KENWOOD

SERVICE BULLETIN AMATEUR RADIO

-	SUBJECT		DATE	
	TS-940S SQUELCH SWITCHING NO.	IȘE	. 7	-21-87

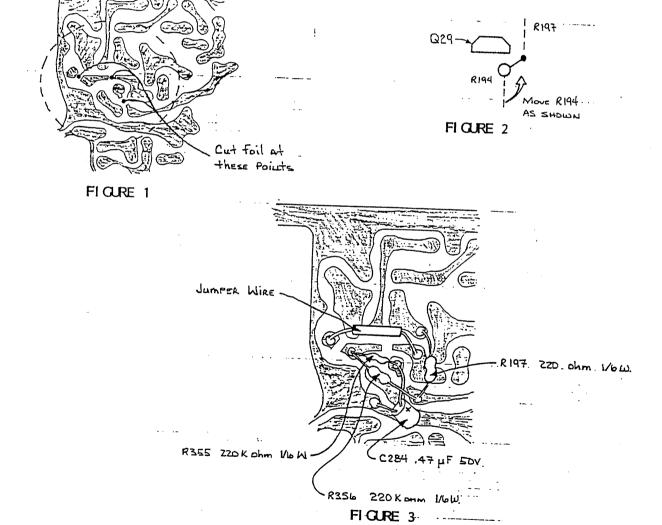
In some TS-940S below S/N 711xxxx, a "popping" or "clicking" noise may be heard when the squelch circuit is opened or closed. This may be more noticeable when an optional CW filter is installed. The following procedure will minimize the noise.

- 8. Using a small craft knife, cut the foil at the 3 points shown in figure 1 (top right corner of the board).
- 9. Unsolder and discard resistors R194 and R197. They are mounted on the component side of the board and soldered on the foil side.

- 10. Install a 560K ohm resistor on the component side of the board as shown in figure 2. This resistor is now designated as R194.

- 11. On the foil side of the board, add the 3 resistors (R197, 355, 356) as shown in figure 3.
- 12. Add a small jumper wire as shown in figure 3.
- 13. Add capacitor C282 as shown in figure 3. Observe polarity and insulate the positive (+) lead with shrink tubing.
- 14. Carefully place the board in its original position (do not pinch wires) and secure it with the 7 screws.
- 15. Plug in connector # 17. Move the 4 wires on the far side of the board back to their original position.
- 16. Put the covers back on the TS-940S and secure them with the 16 case screws.
- 17. Connect the antenna and power cord then test the transceiver for normal operation.

R194	560K ohm	s 1/6W	RD14CB2C564J
R197	220 ohm	s 1/6W	RD14BB2C221J
R355,356	220K ohm	s 1/6W	RD14BB2C224J
C284	0.47 uF.	50V electrolytic	C90-0484-05
